Our ref: DOC24/556164

Subject: Dinawan Wind Farm (SSD-50725708) – Environmental Impact Statement

Adam Vey
20 August 2024
Director South West
Biodiversity, Conservation and Science Group
NSW Department of Climate Change, Energy, the Environment and Water

Figure 1: Northeast corner of stage 2 where threatened flora surveys were not completed in September despite associated PCTs occurring for two September only species (*Swainsona murrayana* and *S.plagiotropis*).

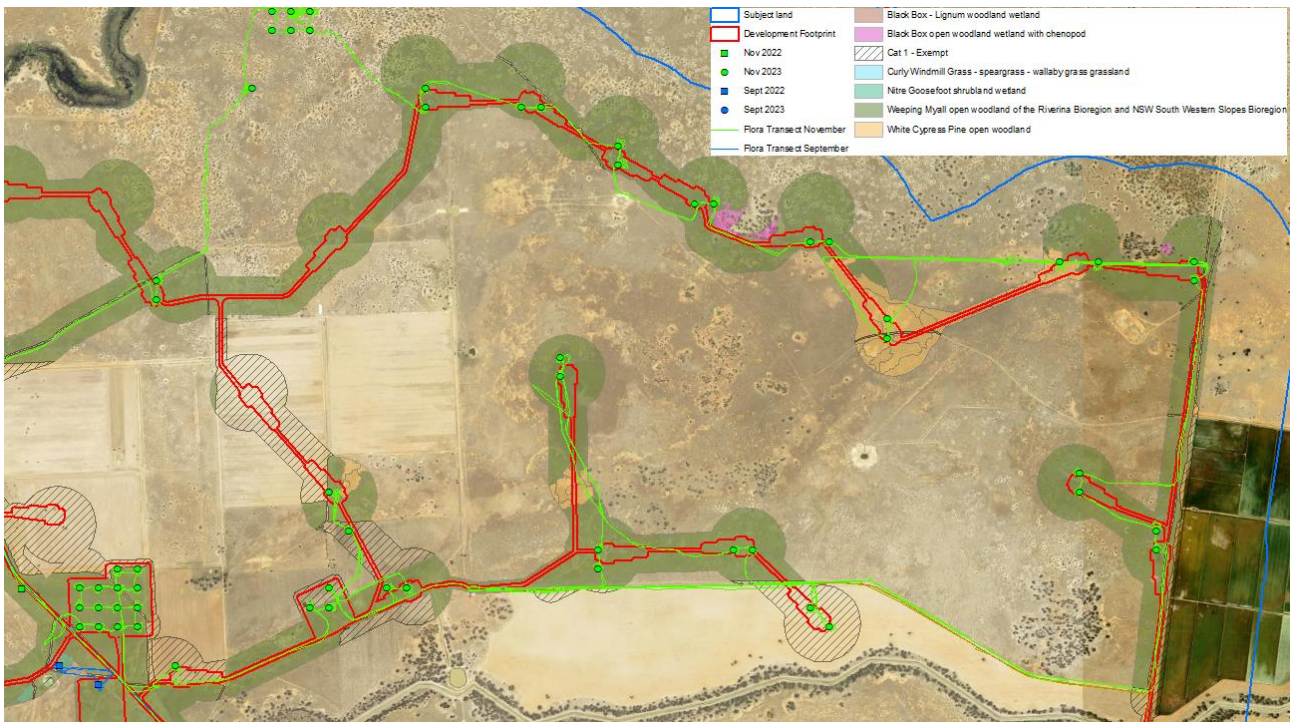
Table 30 of the BDAR shows the level of survey effort completed, by species and total associated PCTs. Although the total areas are comparable with what is required using the large area survey method, there are large areas for which there were no surveys completed in accepted survey months in the grid points or any transects. These areas have no assumed presence species polygons despite surveys not being completed in required survey months.

For example, Figure 1 shows a large area of mostly Weeping Myall woodland that is an associated PCT for *Swainsona murrayana* and *Swainsona plagiotropis*, for which the survey must occur in September. However, the proponent did not complete targeted flora surveys (grid points or transects) for these species in September and did not include assumed presence species polygons for these species. There are other areas like this within the spatial data.

- 5.1. Review threatened flora survey effort data to ensure the spread of survey effort covers all associated PCT grid points in the correct survey months.
- 5.2. Where survey effort including walking transects and grid points have not been completed in the correct survey month, remove this effort from the effort calculations in Table 30.
- 5.3. Remove any driving transects from survey effort calculations and maps then reevaluate additional survey effort for each species.

- 5.4. Complete additional flora surveys in the correct survey month for each flora species to meet the minimum survey requirements set out in the BAM *'Surveying threatened plants and their habitats'* guide or seek agreement from BCS to use a different approach for this project. If additional surveys cannot be undertaken, assume presence or provide an expert report.
